P 520053-A

## ON-SITE SEWAGE DISPOSAL SYSTEM HOWARD COUNTY HEALTH DEPARTMENT BUREAU OF ENVIRONMENTAL HEALTH

ADDRESS: 3301 Jennings Chapel Road PROPERTY OWNER: Reeve Family LLC

| PURPOSE:  | Septic system is failing. Call for inspection when the ground has been opened so sanitarian can recommend repair.                                                                                                                 |

# Jennings Chapel Road

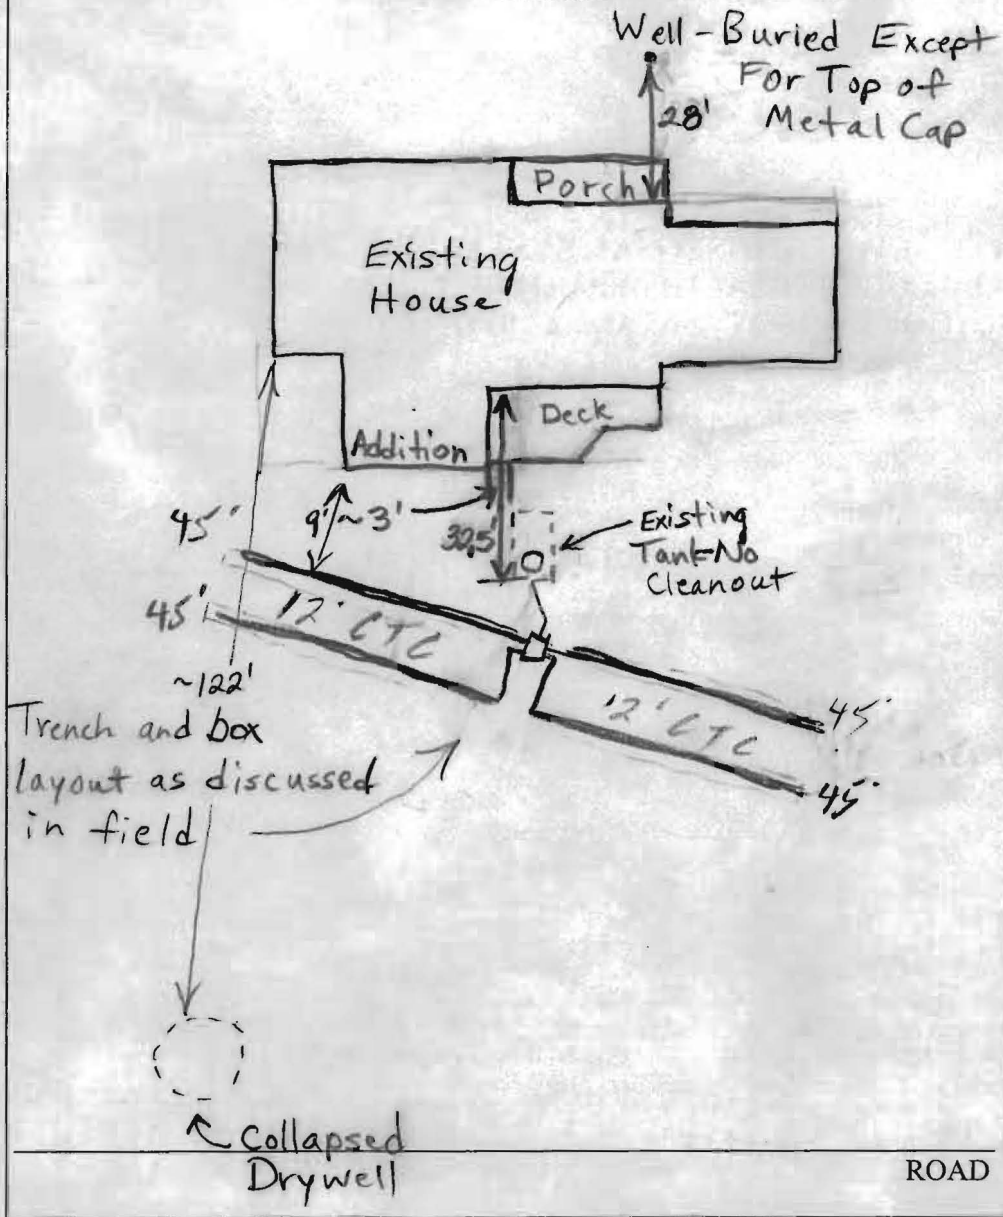
PRE-CONSTRUCTION 2/13/04 Drywell has collapsed. Pump and fill in drywell. Pump out tank and install manhole cleanout. Set a distribution box after tank and run trenches in both directions. There should be 4 trenches with a total length of 180 feet. Made recommendation to owner that they may want to replace the septic tank with larger traffic bearing tank. Tank 6.5' below grade. (BB)

2/17/04 - OK to cover all work. D. Well collapsed, filled in (SD)

| SEPTIC TANK CAPACITY (GALLONS):  | <u>Existing</u> | <u>3' Wide Trenches<br/>Inlet at 7'<br/>Max. Bottom Depth 9'<br/>2' of Stone</u> |
